MIL-PRF-19500/158U
w/AMENDMENT 1
8 March 2021
SUPERSEDING
MIL-PRF-19500/158U
18 January 2019

PERFORMANCE SPECIFICATION SHEET

SEMICONDUCTOR DEVICE, DIODE, SILICON, VOLTAGE-REFERENCE,
TEMPERATURE COMPENSATED, TYPES 1N3154-1 THROUGH 1N3157-1
LEADED AND SURFACE MOUNT PACKAGES, QUALITY LEVELS JAN, JANTX, JANTXV, AND JANS,
RADIATION HARDENED (TOTAL DOSE ONLY)

* FIGURE 2. Physical dimensions of DO-213AA package (1N3154-1 through 1N3157-1).

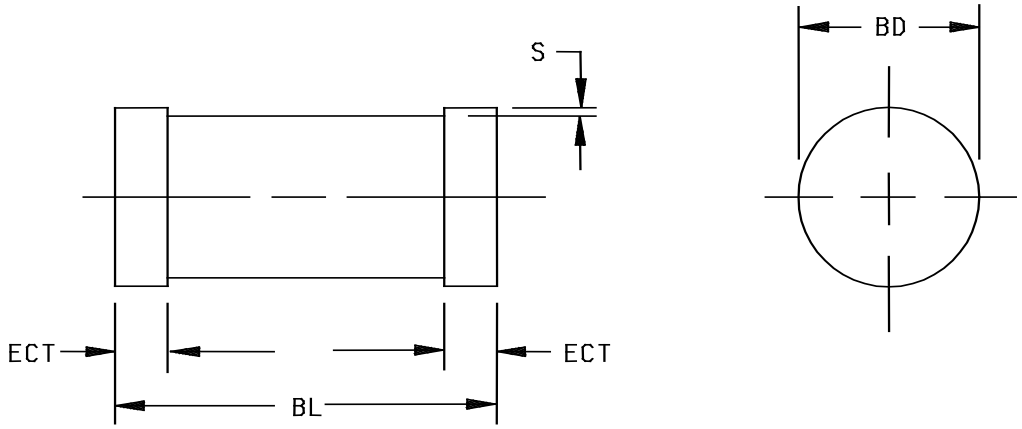
NOTES:
1. Dimensions are in inches. Millimeters are given for general information only.
* 2. In accordance with ASME Y14.5, diameters are equivalent to ϕx symbology.
* 3. Dimension S is optional however the glass body diameter shall not exceed endcap diameter.
